A47 North Tuddenham to Easton Dualling

Scheme Number: TR010038

9.26 Non-Material DCO Changes Request

NON-MATERIAL DCO CHANGES REQUEST

Figure 2.2 – Before and After Image of Proposed Change

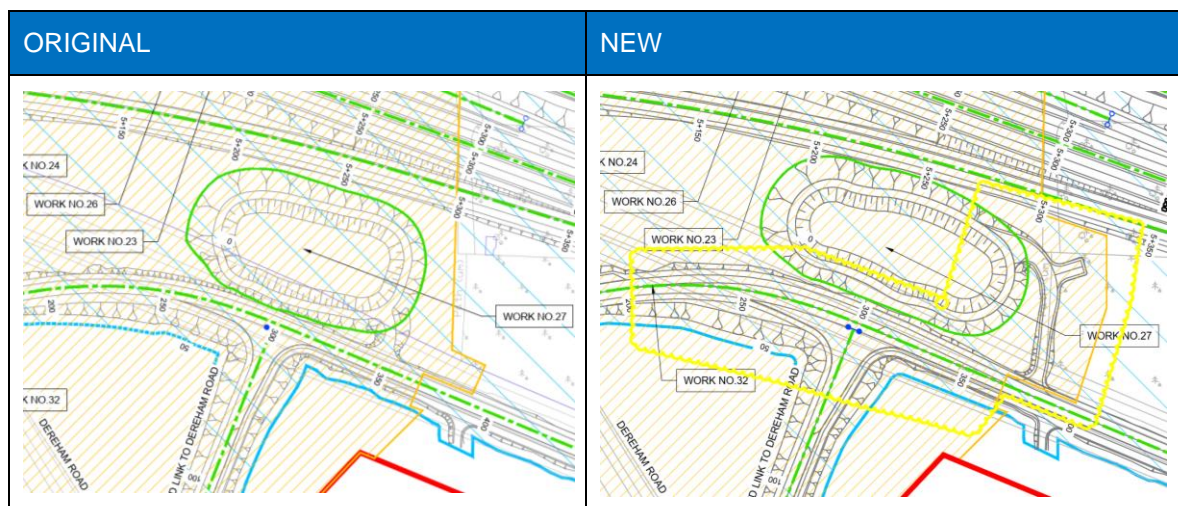
2.3.1 This design change involves the addition of a ghost island for turning right into the realigned Dereham Road (leading to Honingham) from the de-trunked A47. This design change involves the following within the existing highway limit of deviation:

- minor, localised widening of the existing A47 northwards at the junction with Dereham Road (Work No. 32)
- altering the shape of the drainage basin adjacent to the junction to reflect the northward movement of the highway's northern edge (Work No. 27), which has required the need to move the existing A47 connection to the maintenance access track 35m to the east (also Work No. 27)

2.3.2 The drainage basin change also requires a minor rerouting of the access track eastward by 35m. This improves the provision of access from the drainage basin access track to the Vodafone mast north-east of the drainage basin, between the existing and new A47 alignments.

- 2.3.3 Work No. 84 (minor works limit of deviation) has been extended eastward slightly, within existing permanent landtake area, to cater for possible utilities works around the new access track location.

- 2.3.4 This design change is illustrated in Figure 2.2 below and Sheet 9 of the DCO plans listed in Table 2.2 has been updated to show this slight change in the design.

Figure 2.3 – Before and After Image of Proposed Change

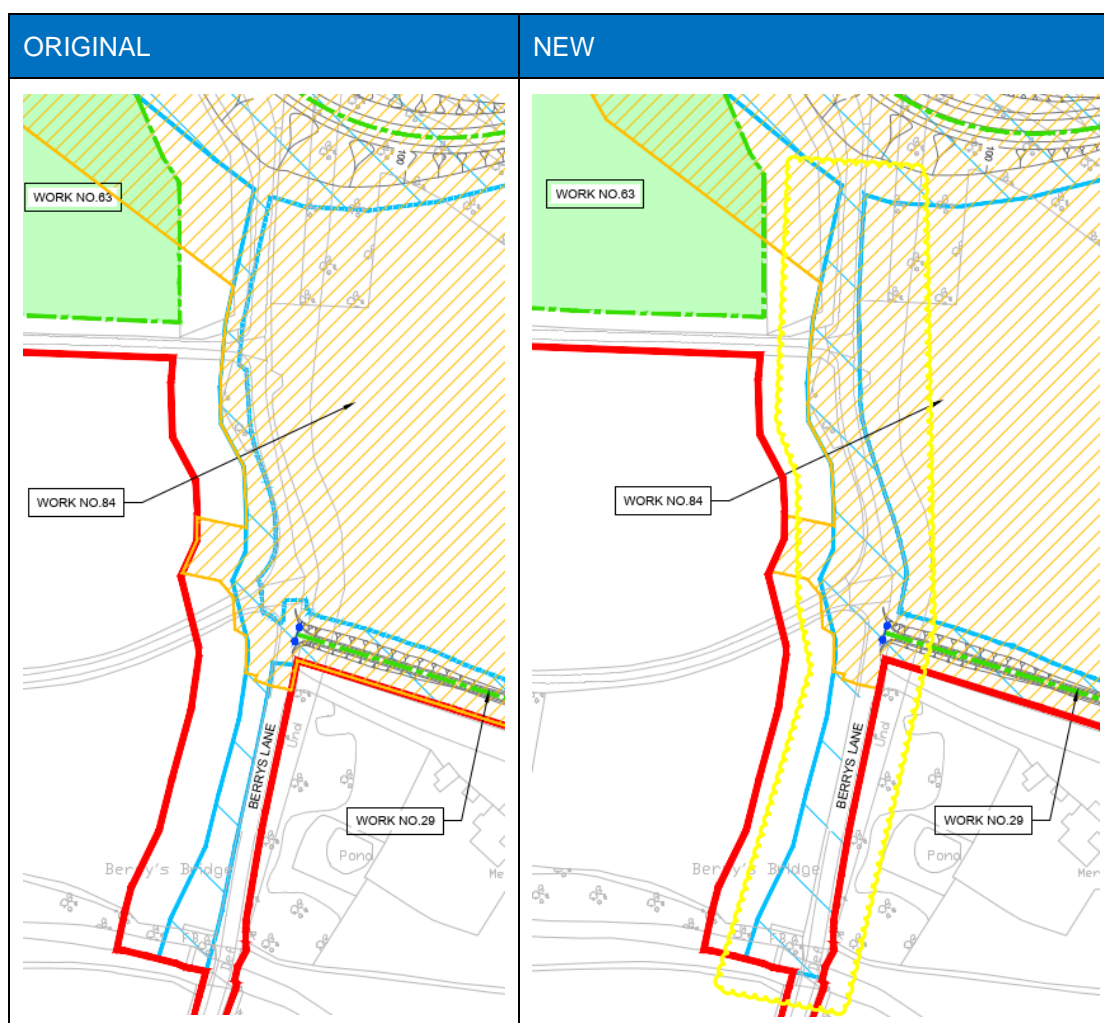
- 2.4.1 This design change is to widen slightly the eastern extent of the highway limit of deviation along Berrys Lane to encompass the whole of Berrys Lane within the Order limits.

- 2.4.2 This is to allow the Applicant at the detailed design stage to continue exploring the option to tie into the existing drain on the east side of Berrys Lane, following discussions with the landowner during the Examination period. This is a non-material change to the DCO design as it would simply permit the option to tie-in to the northern end of a drainage system between the existing A47 and the River Tud.

- 2.4.3 This design change is illustrated in Figure 2.3 below and Sheet 9 of the DCO plans listed in Table 2.3 has been updated to show this change in the design.

Figure 2.4 – Before and After Image of Proposed Change

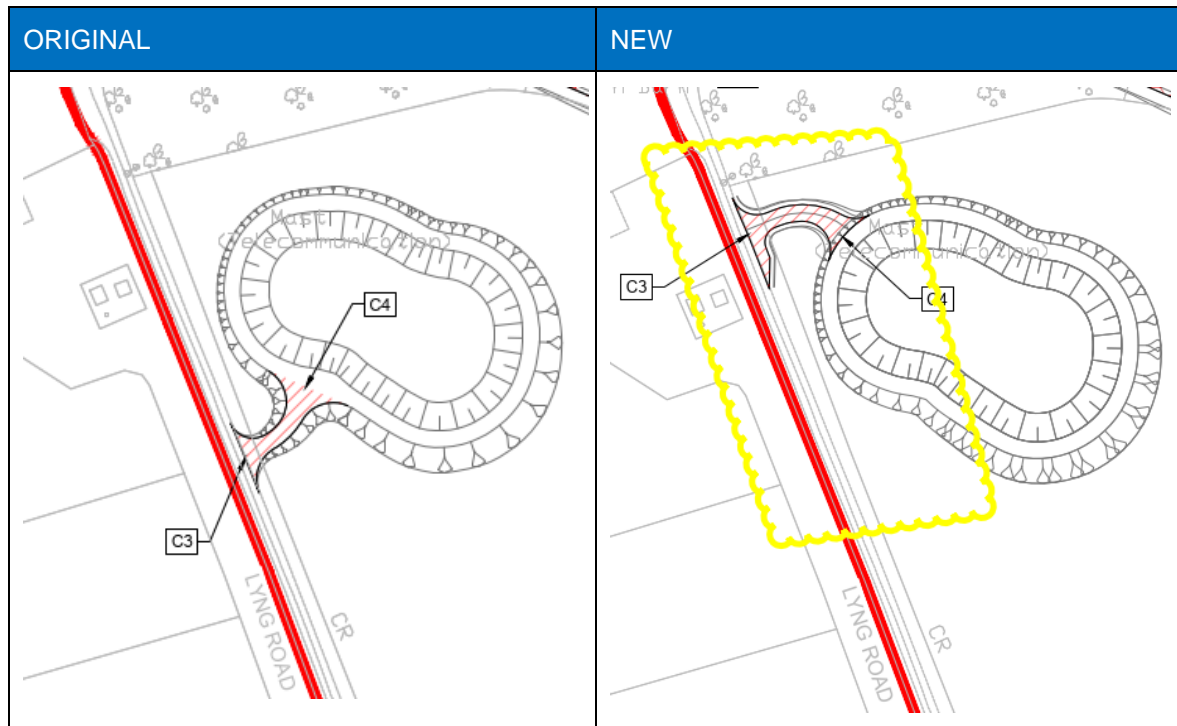
- 2.5.1 This design change involves moving the access point at the drainage basin on Lyng Road, south of the existing A47 (dDCO Work No. 6), to provide a shared turning area beside the Vodafone mast across Lyng Road opposite the drainage basin.
- 2.5.2 This design change is illustrated in Figure 2.2 below and Sheet 4 of the DCO plans listed in Table 2.2 has been updated to show this change in the design.
- 2.5.3 This design change does not result in any additional permanent land take as it is just a re-arrangement within the permanent landtake for this drainage basin.
